UNITED STATES PATENT AND TRADEMARK OFFICE

APPLICATION NO.	FILING DATE	FIRST NAMED INVENTOR	ATTORNEY DOCKET NO.	CONFIRMATION NO.
10/783,748	02/20/2004	Alexandros T. Demos	008514/DSM/BCVD/JW	7358

Office Action Summary	Application No.	Applicant(s)	
	10/783,748	DEMOS ET AL.	
	Examiner	Art Unit	
	Khiem D. Nguyen	2823

DETAILED ACTION

**FIG. 2A**

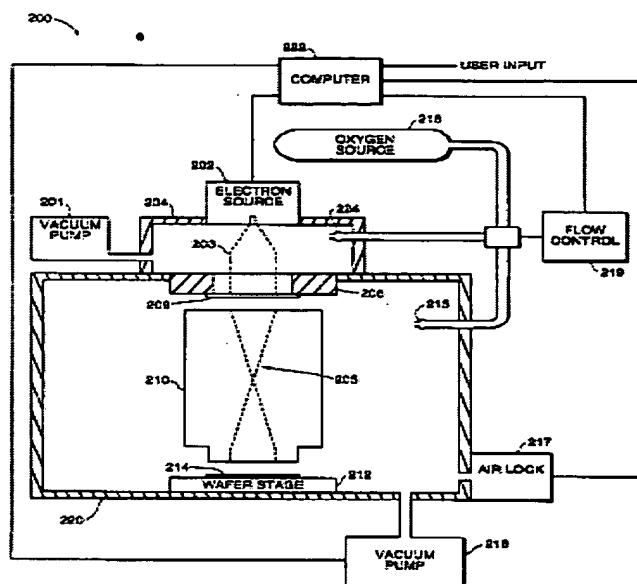
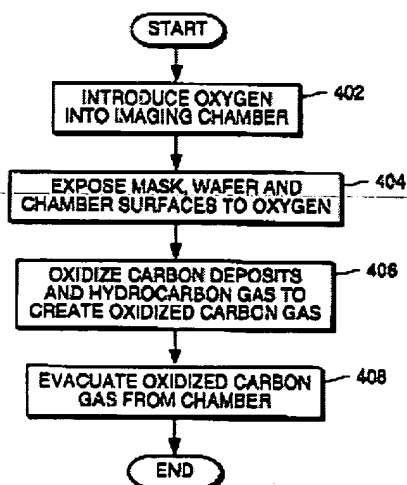
In re claim 1, Somekh discloses a method of cleaning a chamber of an electron beam treatment apparatus 200 the method comprising: generating an electron beam 205 (col. 4, lines 19-34 and FIGS. 2A)

that energizes a cleaning gas (O_3 , N_2O) (col. 5, lines 39-56) in the chamber of the electron beam treatment apparatus; monitoring an electron beam current; adjusting a pressure of the cleaning gas to maintain the electron beam current at a substantially constant value; and stopping when the cleaning gas pressure becomes substantially constant for a predetermined length of time (col. 5, line 66 to col. 6, line 30 and FIG. 4).

FIG. 2A

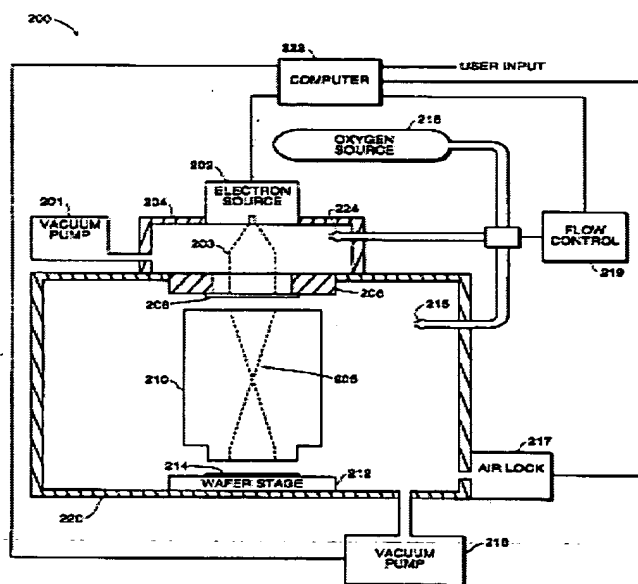
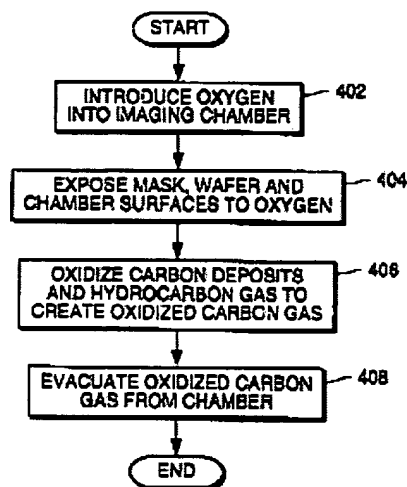
In re claim 8, **Somekh** discloses a method of cleaning an electron beam treatment chamber 200, the method comprising: generating an electron beam 205 (col. 4, lines 19-34 and FIG. 2A)

that energizes a cleaning gas (O₃, N₂O) (col. 5, lines 39-56) in the electron beam treatment chamber; and stopping after the cleaning gas pressure becomes substantially constant for a predetermined length of time (col. 5, line 66 to col. 6, line 30 and FIG. 4).

**FIG. 2A**

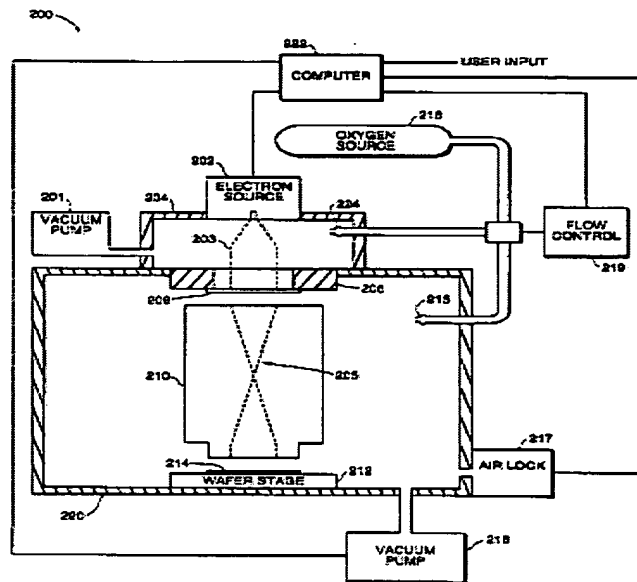
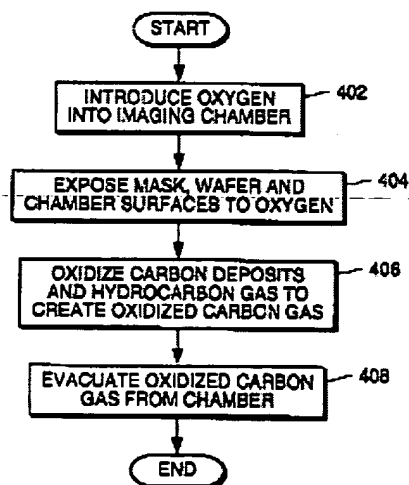
In re claim 16, Somekh discloses a method of cleaning a chamber of an electron beam treatment apparatus 200, the method comprising: Introducing a cleaning gas into the chamber (col. 5, lines 39-56); generating an electron beam 205 that energizes the cleaning gas in the chamber (col. 4, lines 19-34 and FIG. 2A);

setting in the chamber, an electron beam current of about 10 mA or above;

adjusting a pressure of the cleaning gas to maintain the electron beam current at a substantially constant value; and determining an endpoint of the cleaning process and stopping introduction of the cleaning gas when the cleaning gas pressure reaches a substantially constant value (col. 5, line 66 to col. 6, line 30 and FIG. 4).

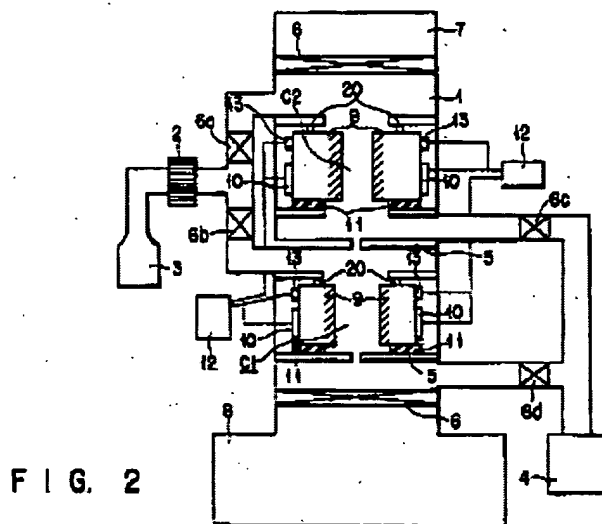
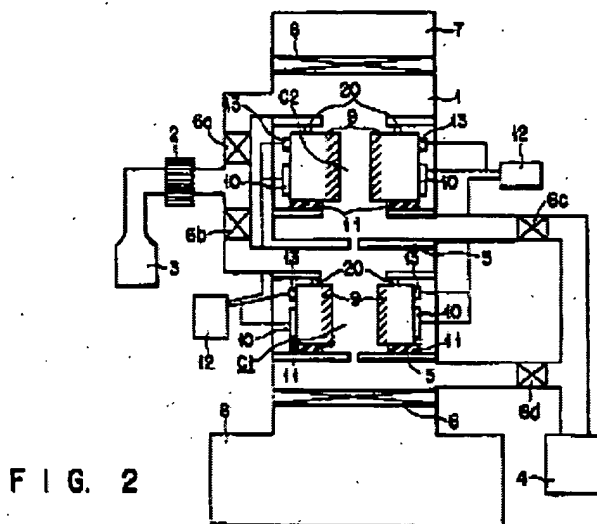
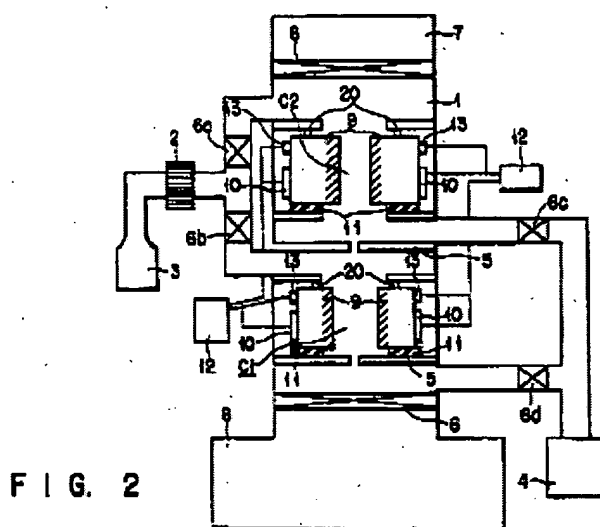
In re claim 1, **Ohtoshi** discloses a method of cleaning a chamber of an electron beam treatment apparatus, the method comprising: generating an electron beam 7 that energizes a cleaning gas (O₂, CF₄) in the chamber of the electron beam treatment apparatus (col. 11, line 50 to col. 12, line 58 and **FIG. 2**);

In re claim 8, **Ohtoshi** discloses a method of cleaning an electron beam treatment chamber, the method comprising: generating an electron beam 7 that energizes a cleaning

gas (O_2 , CF_4) in the electron beam treatment chamber (col. 11, line 50 to col. 12, line 58 and FIG. 2);

In re claim 16, **Ohtoshi** discloses a method of cleaning a chamber of an electron beam treatment apparatus, the method comprising: introducing a cleaning gas into the chamber; generating an electron beam 7 that energizes the cleaning gas (O_2 , CF_4) in the chamber (col. 11, line 50 to col. 12, line 58 and FIG. 2);
